MONTGOMERY
SQUARE SWIM CLUB

FALLS ROAD (MD 189)

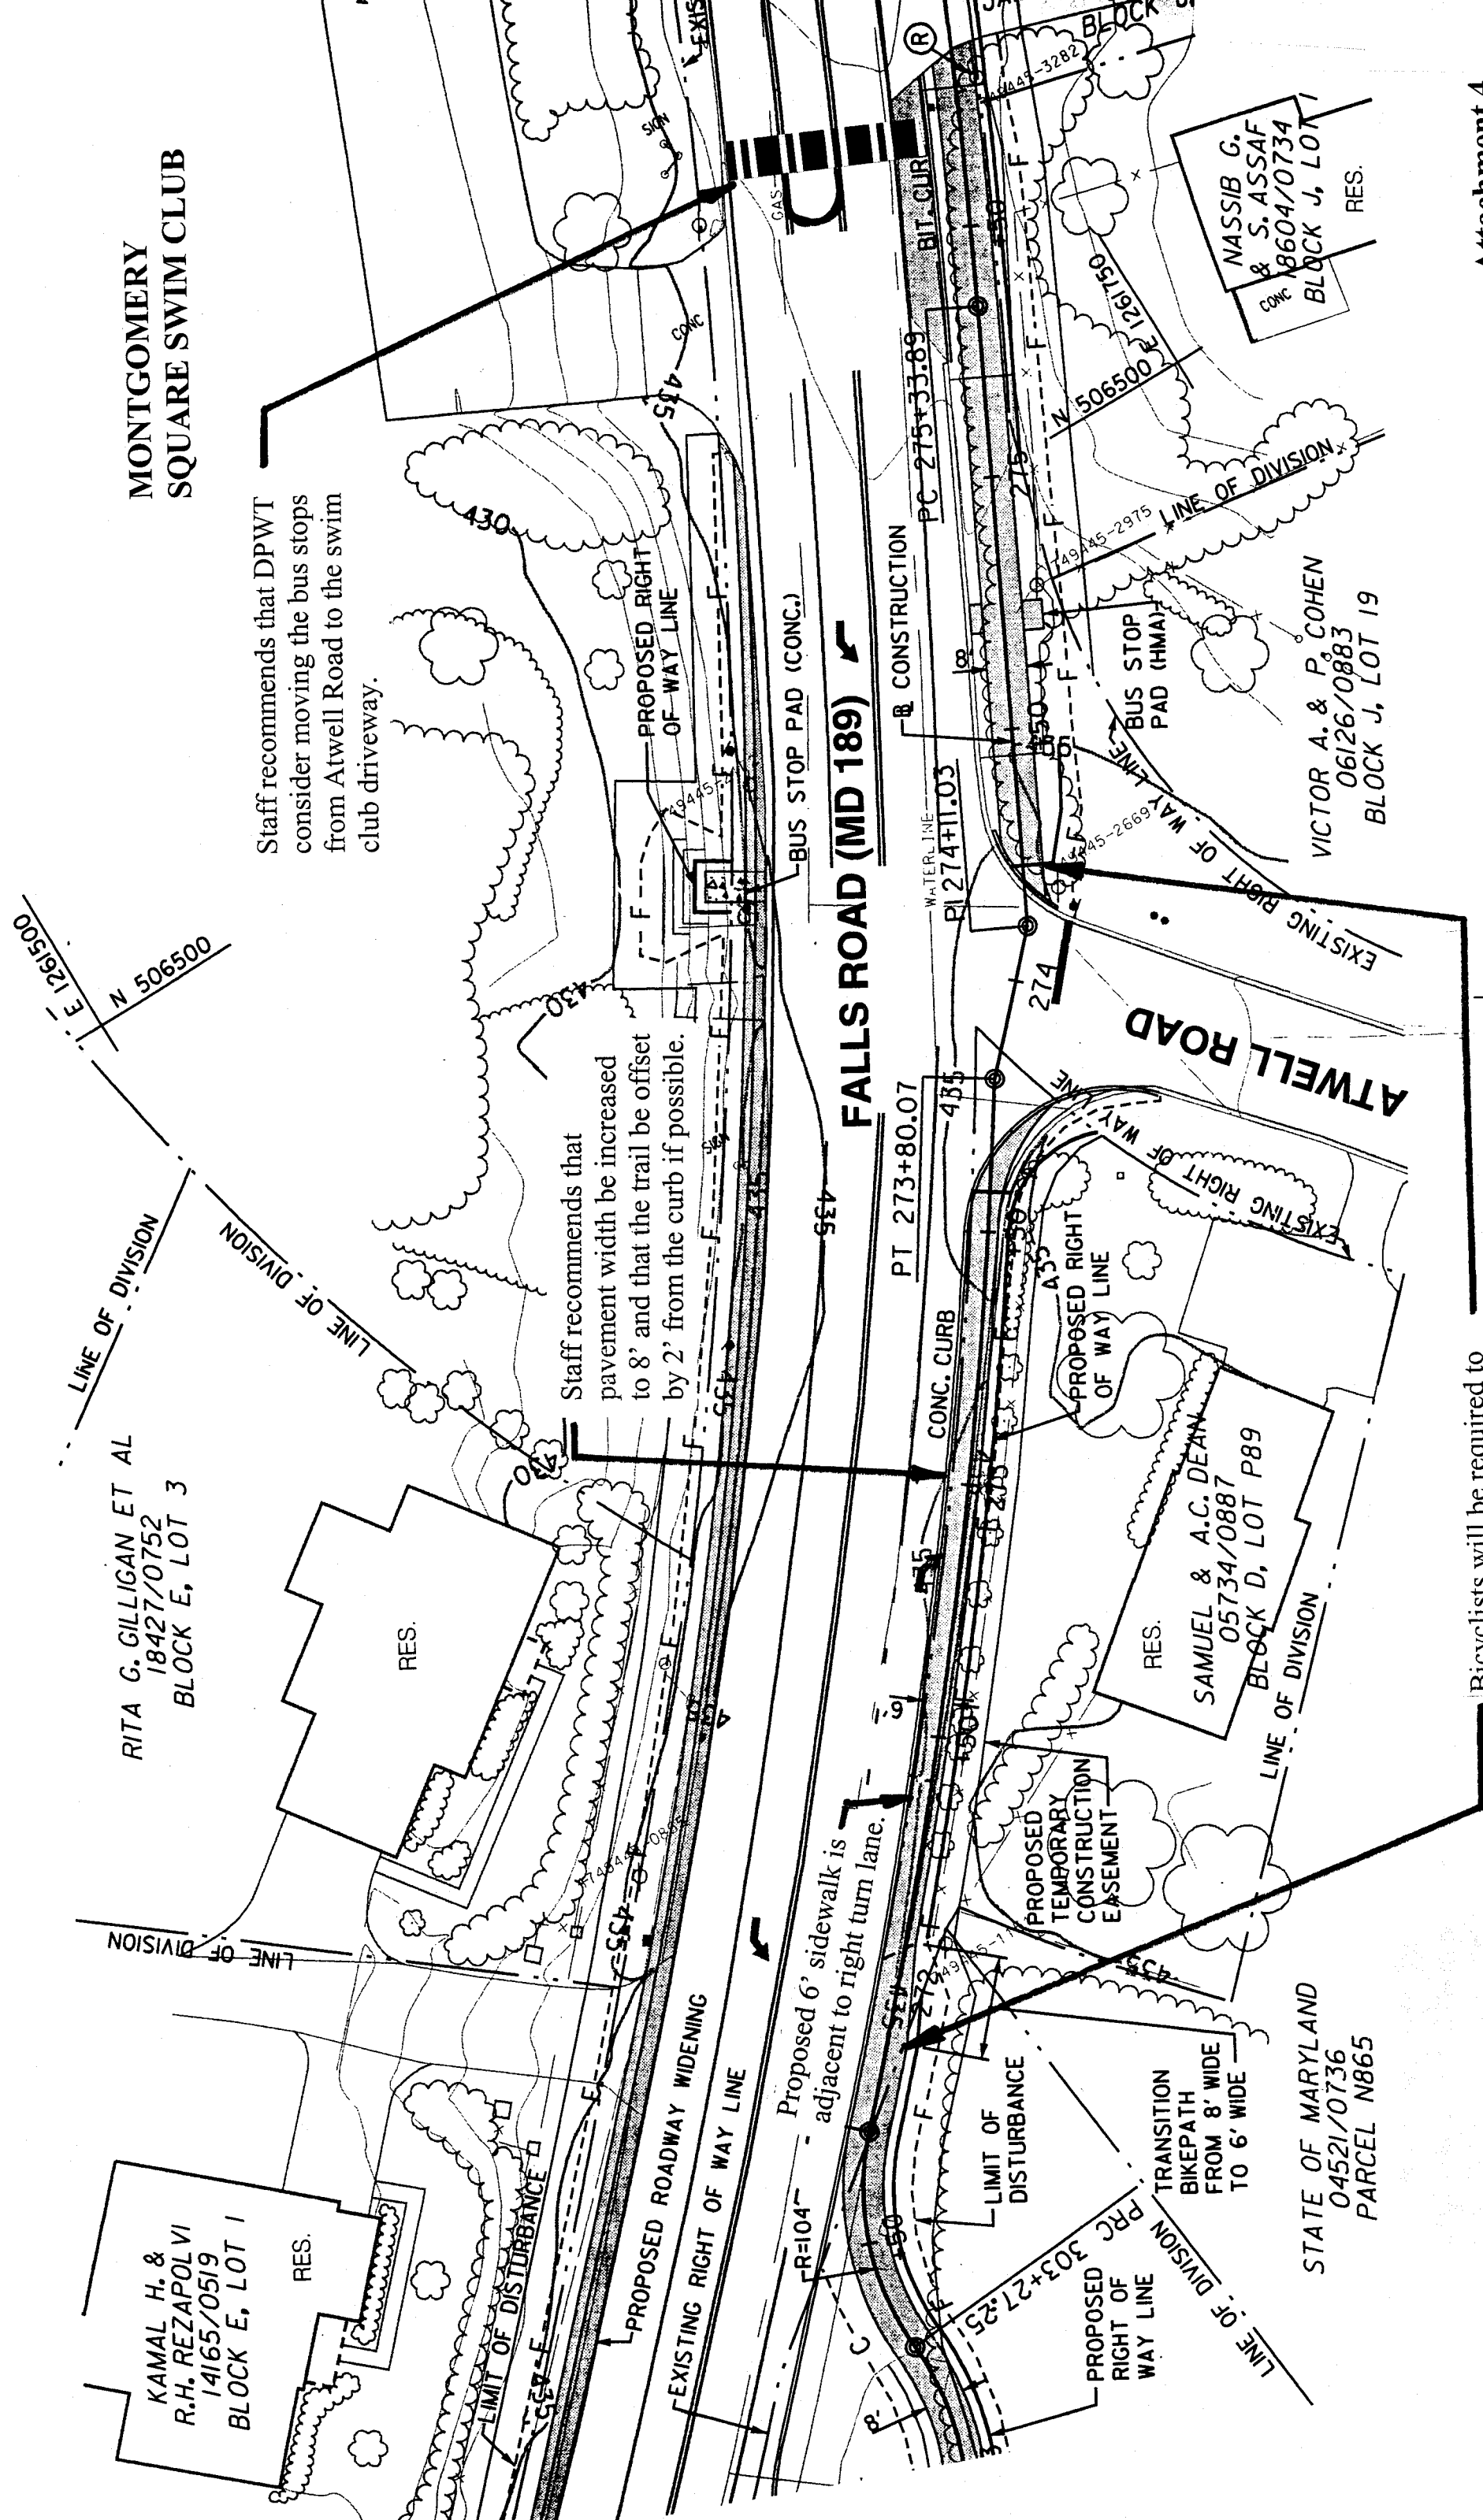
Staff recommends that DPWT
consider moving the bus stops
from Atwell Road to the swim
club driveway.

Staff recommends that
pavement width be increased
to 8' and that the trail be offset
by 2' from the curb if possible.

Proposed 6' sidewalk is
adjacent to right turn lane.

Bicyclists will be required to
dismount here.
